Access Compliance Report

Public Rights-of-Way

(Curb Ramps)

Intersection ID: 46189	Main Street: GALARDIA_RD	Cross Street: YAUPON_RD	Location:	N
ADA ID: 0B9C449456D5	Ramp Type: BlendTrans1	Initial Pass/Fail: Pass	Overall Compliance: No	Severity Score: 20
Codes/Mitigation Info/Possible Solution		Field Measurements/Component Compliance

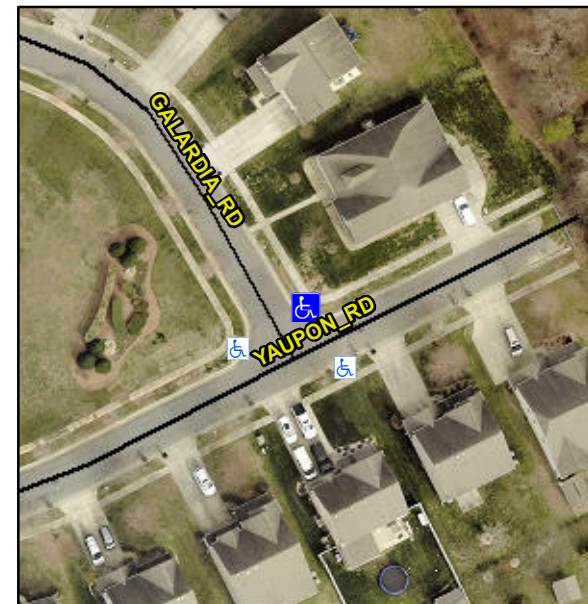
Not Found, R304.2.1, R304.5.3, R305.2, R302.7, R302.7.2, R304.5.4

Compliance	Description	Data	Compliance	Description	Data
N/A	Ramp Length (in)	70.5	Yes	BlendTrans Slope (%)	4.3
Yes	Ramp Width (in)	48.0	Yes	BlendTrans XSlope (%)	1.9
N/A	Flare Type LT	Sloped	N/A	Flare Type RT	Sloped
N/A	Flare Slope LT (%)	0.6	N/A	Flare Slope RT (%)	5.2
N/A	Flare Traversable LT?	No	N/A	Flare Traversable RT?	No
No	Landing Length (in)	47.5	Yes	DWS Provided?	Yes
Yes	Landing Width (in)	48.0	Yes	DWS Contrast?	Yes
Yes	Landing Slope (%)	1.2	Yes	DWS Length (in)	25.0
No	Landing X Slope (%)	3.2	Yes	DWS Full Width?	Yes
N/A	Landing Curb? (Y/N)	No	No	DWS Offset (in)	8.0
N/A	Shared Landing?	No			
No	Gutter Ponding?	Yes	No	Gutter Slope (%)	12.4
No	Gutter Lip Ht (in)	2.0	No	Gutter X Slope (%)	2.8
N/A	Painted X Walk1?	No	N/A	Painted X Walk2?	No
	X Walk 1 Direction	To SW		X Walk 2 Direction	To SE
	X Walk 1 Width (in)	N/A		X Walk 2 Width (in)	N/A
	X Walk 1 Slope (%)	1.1		X Walk 2 Slope (%)	2.7
	X Walk 1 X Slope (%)	2.2		X Walk 2 X Slope (%)	1.8

N/A	Ramp inside XWalk1?	N/A	N/A	Ramp inside XWalk2?	N/A
	Road Slope (%)	0.9		Clear Space?	Yes
	Road X Slope (%)	2.0	N/A	Clear Space to XWalk (in)	N/A
Yes	Any Obstructions?	No	Yes	Storm Grate/Utility Hazard?	No
	Obstruction Type			Storm Grate/Utility Type	
		N/A			N/A
			Yes	Surface Condition? (G/P)	Good
			No	Curb Slope (%)	15.6

Remove & Replace Curb Ramp With Two New Directional Ramps or Equivalent. Remove & Replace Gutter.
